Model Name : KDL-40/46D3660

Differences Manual

WAX3F CHASSIS

Note: This Service Manual shows only the differences from KDL-40D3400/KDL-40D3500.
Refer to the Service Manual (9-927-590-xx) of KDL-40D3400/KDL-40D3500, also for repair.

5-2. REAR COVER, STAND & BEZEL

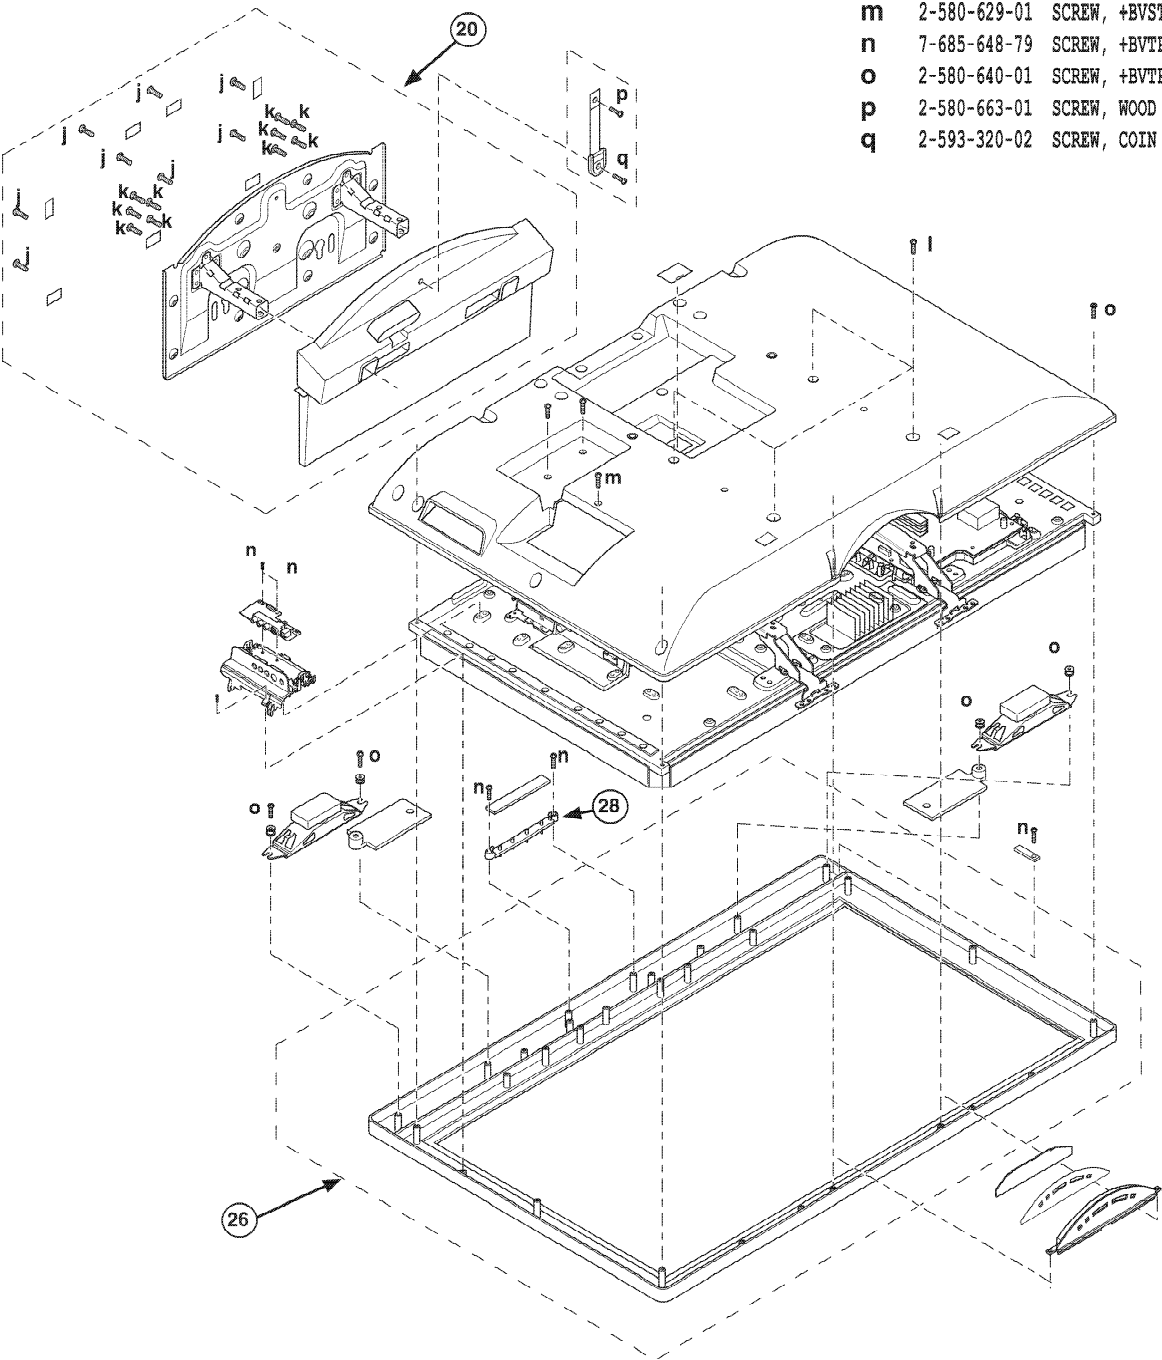
REF.NO.	PART.NO	DESCRIPTION	REMARK	REF.NO.	PART.NO	DESCRIPTION	REMARK
20	*X-2187-437-1	STAND (ML) ASSY	(40 inches)	26	X-2187-585-2	BEZEL (40DE2) ASSY	(40 inches)
	*X-2187-438-1	STAND (L) ASSY	(46 inches)		X-2187-586-2	BEZEL (46DE2) ASSY	(46 inches)
